Delegated officer report for planning application

Application no. 136828/FH/2023
Date registered valid: 27 April 2023
Proposal: Infill extension to front elevation at first floor to extend existing bathroom over porch.
Address: 12 Didsbury Park, Manchester, M20 5LJ
Ward(s): Didsbury East Ward

Description of development

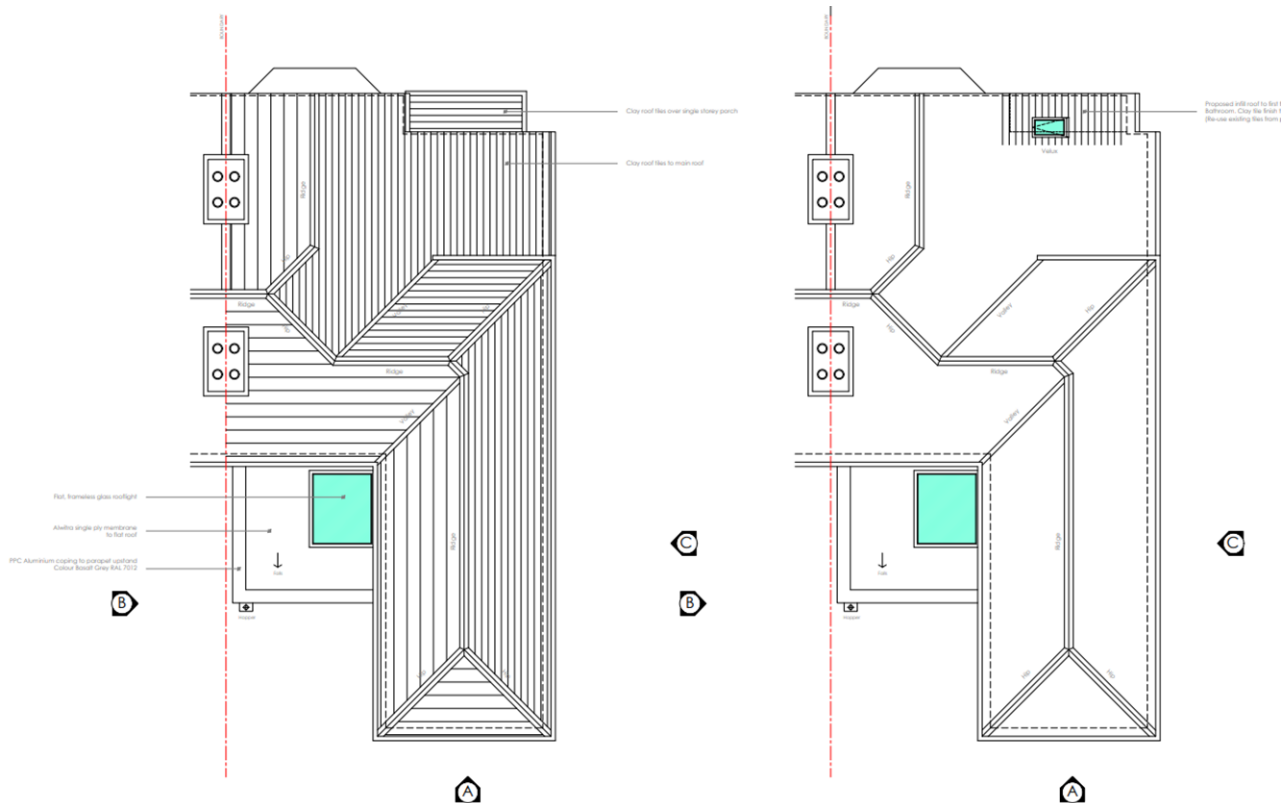
The applicant seeks to erect a first floor front extension above the existing porch measuring 2.60m in width to a length of 900mm approximately in line with the ground floor. The roof line would continue adjoining the existing slope of the roof with the inclusion of a roof light to the side. The porthole window would be reinstated to the front retaining what is a common feature along the road.

The character to the front of the property would be retained as the applicant proposes a sloping roof reflecting the original. Given the gap to the shared boundary with the adjacent property no. 14 Didsbury Park, it is considered that the proposal to the front would not provide terracing. The extension would be visible from the public highway and therefore would feature within the street scene, however, the character of the property would be retained. Houses in the immediate vicinity are themselves altered and extended. Front, side and rear extensions are particularly popular. The appearance is therefore considered acceptable and its impact upon visual amenity is thought to be negligible.
